# Remedy for noises towards the accessory unit drive

Manufacturer: Opel / Vauxhall

Models: Astra H, Signum, Vectra C, Zafira B

Engines: Z18XER

Image 1: Changing a rigid belt pulley on an over-running alternator pulley

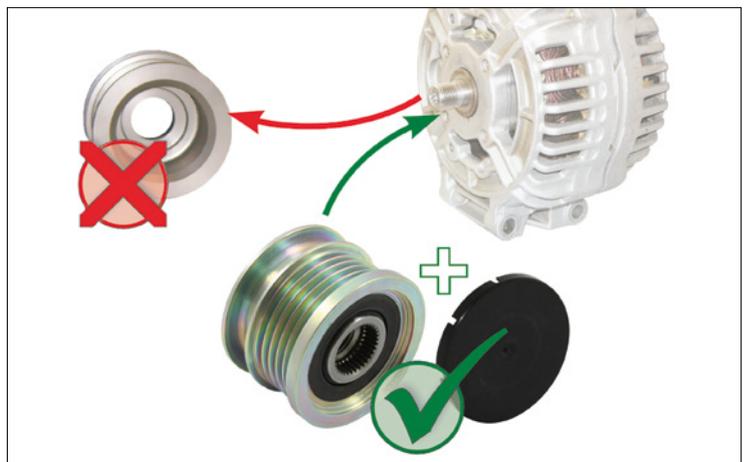
Due to the strong vibrations of the V-ribbed belt, loud noises may be produced in the vehicles listed above with a rigid alternator belt pulley.

As a technical solution, Schaeffler Automotive Aftermarket offers an over-running alternator pulley for these vehicles. This reduces the dynamic loads in the accessory unit drive, thus preventing noise emissions.

Schaeffler Automotive Aftermarket recommends that the vehicles affected be retrofitted with an over-running alternator pulley 535 0143 10.
